OSRAM
Opto Semiconductors

OS-PCN-2020-009-A

New Separation Technology for IR Pulsed Lasers SPL DS90A_3, SPL TL90AT08, SPL UL90AT08, SPL BP90-06-8-03B, SPL DP90_3, SPL TL90AT03 and SPL UL90AT03

Schematic drawing (front side)

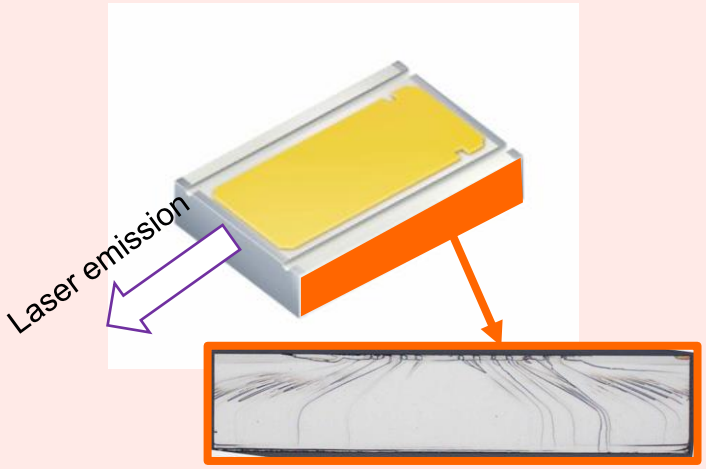
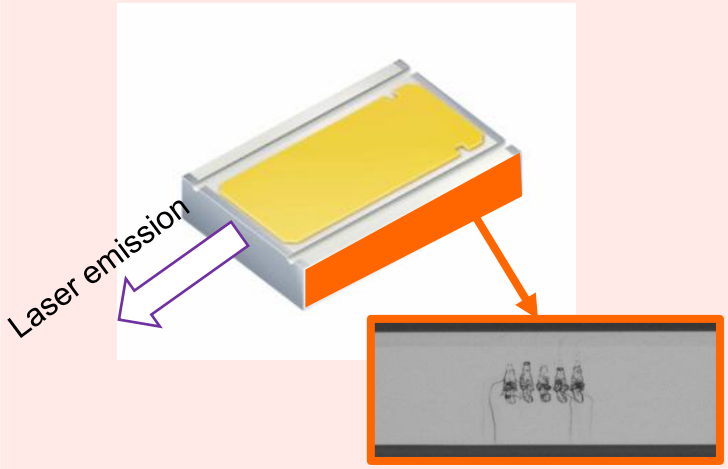
Item	Current status	New status
1	Visible at both laser bar non facet side Both technologies mixed in production.	
1
